**RE: TDE Review – Traffic Analysis Review:
Relocated Costco Main Entrance off Rapp Road Follow-up**

- Traffic analysis Follow-up letter for Relocated Full Access Driveway on Rapp Road, dated November 11, 2022

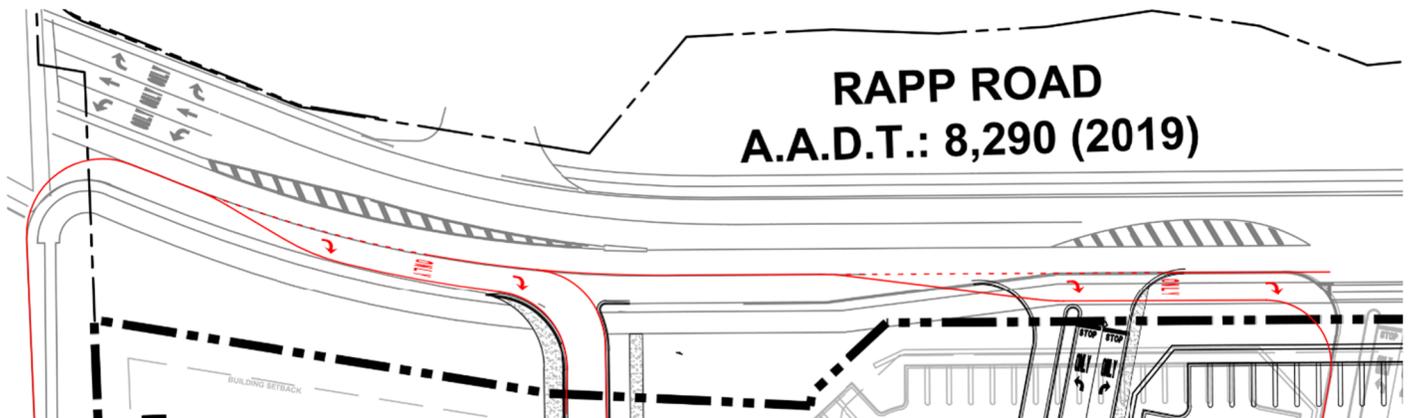
- There is also a concern, regarding the site access points along Rapp Rd that vehicles entering the rightmost lane northbound that want to continue through to the mall do not have sufficient space to safely merge. That the current northbound Rapp Rd lane configuration can be considered confusing and could be a safety concern. It is recommended that the rightmost lane be closed at the Western Avenue intersection and that only one receiving lane be present at the intersection, this lane would continue up to Crossgates, Mall Rd. Right turn lanes at the two Costco site entrances could be formed individually from that singular through lane, see below for rough concept:
